SERVICE LETTER

No. 823

Piper Aircraft Corporation

Subject: Heater/Evaporator Return Air Duct Hose Replacement

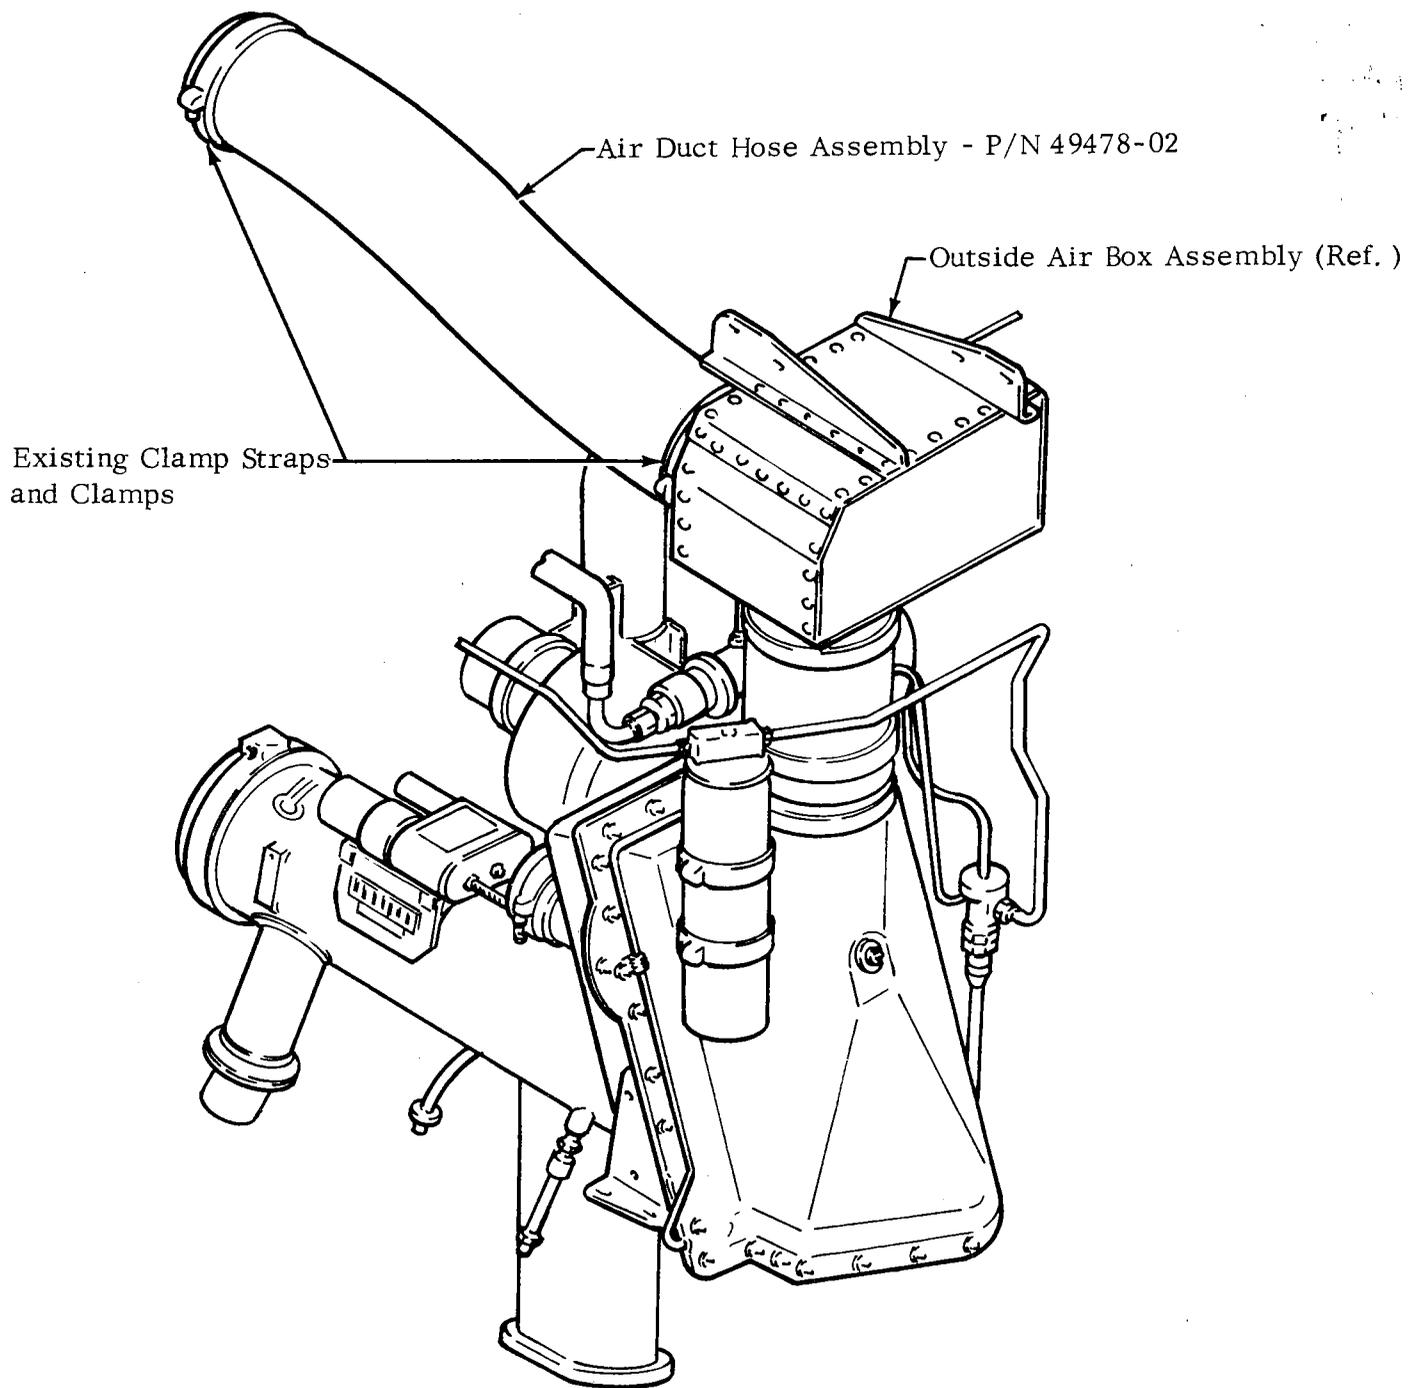
Purpose: The Heater/Evaporator Return Air Duct Hose, Piper part number 55574-02 installed on the aircraft referenced above may separate internally, allowing material to impede the operation of the recirculating blower fan. This in turn can cause loss of the heater/airconditioning circulation system.

This service release announces the availability of new redesigned hose assemblies internally reinforced to prevent internal hose separation and possible loss of the heater/airconditioning circulation system.

Material Required: One (1) each per aircraft Heater/Evaporator Return Air Duct Hose, Piper part number 49478-02.

1. Remove the access panel from the right side of the fuselage nose section.
2. Replace the existing return air duct hose assembly with new assembly P/N 49478-02. Use the existing clamp straps and clamps to secure new hose assembly.
3. Reinstall access panel to fuselage nose section.
4. Make proper logbook entry of Service Letter compliance.
